Planning Application No. A/YL-KTN/1281

Table A: Responses to Departmental Comments

擬議臨時康體文娛場所 (板式網球)

No. : CZIN2309000076CM01_EN

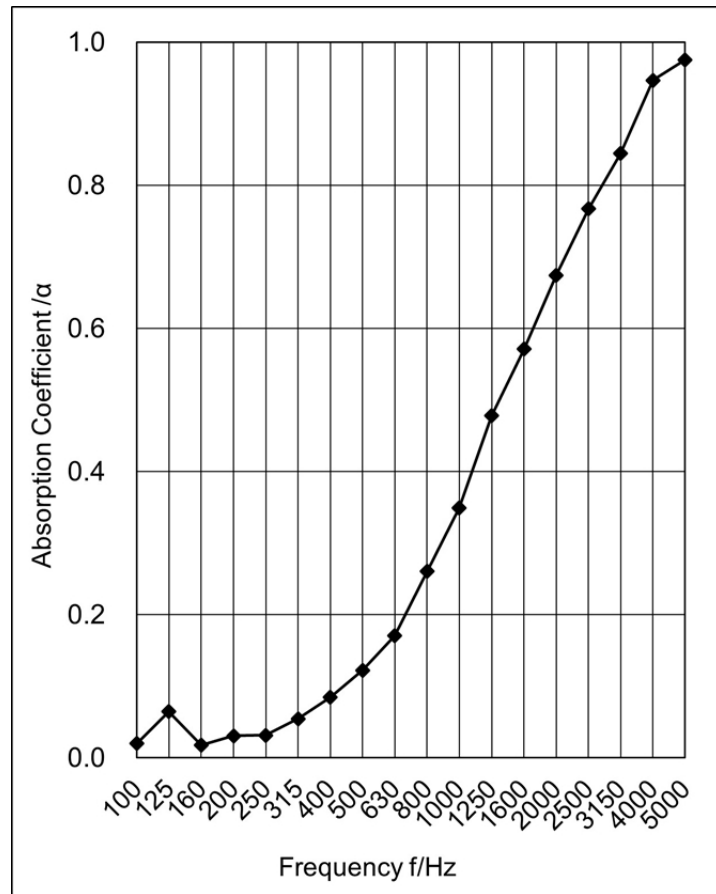
2	The test report for the sound-absorbing panels (test report CZIN2300000076CM01_EN) is missing compared to the FI under A/YL-KTN/1198. Please supplement in Appendix 2.	申請人已將吸音板的相關測試報告補充於附件 2 中，請查閱：修正後的附件 2。
